CERTIFICATE OF APPROPRIATENESS

Property: 8106 Glen Valley Dr, lot 2, block 3, Glenbrook Valley Sec 1 Subdivision. The property includes a historic 2,730 square foot residence situated on a 12,892 square foot interior lot.

Proposal: New Construction – Construct an approximately 260 square foot accessory structure at the rear of the lot.

SITE PLAN

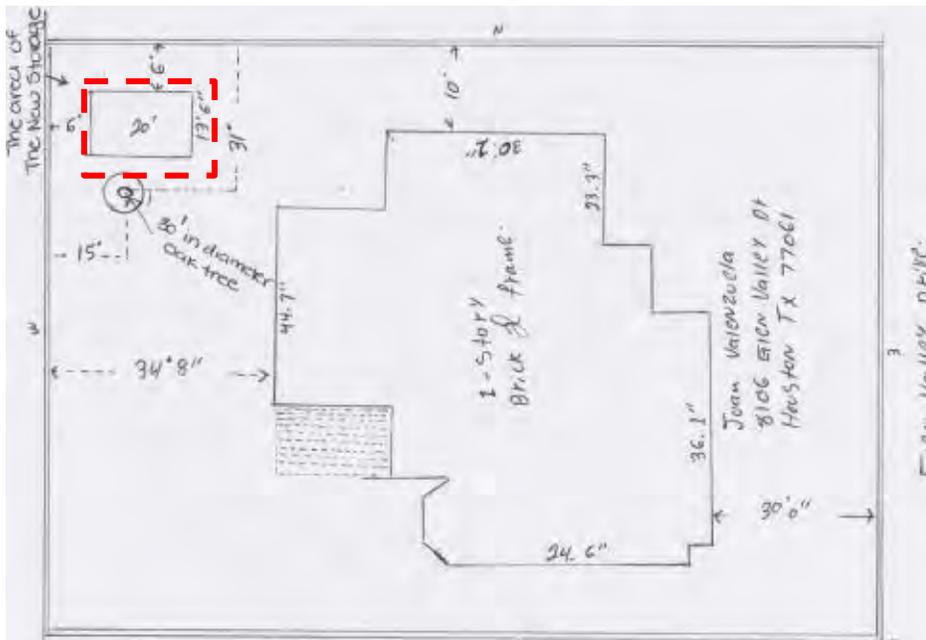
- The application was deferred at the October 23, 2014 meeting due to concerns that the structure was not compliant with the neighborhood’s deed restrictions.
- The new proposal situates the structure at 6’ from the side and rear property lines.

8106 Glen Valley Drive: The property owner's application, specifically, the sketches are misleading. It appears as if a ~260 square foot (13.5" by 20") structure is being built within the 10 foot side setback and may be a secondary residence which would be a deed restriction violation.

Therefore, the outbuilding does not violate the deed restrictions. I have sent an email to the Omar Izfar, another lawyer in the Legal Department who works with the HAHC, to let him know your concerns regarding the possibility that the intent is to build a second residence which is, of course, specifically prohibited by the deed restrictions.

The other issue regarding the side setback is, I believe, equally clear. As you pointed out, the outbuilding is not part of the residence. Therefore, as provided in the deed restrictions, it is not subject to the side setback. The restrictions provide the outbuilding must not be built nearer to the front than the building line. The sketch provided shows it to be in compliance with the building line.
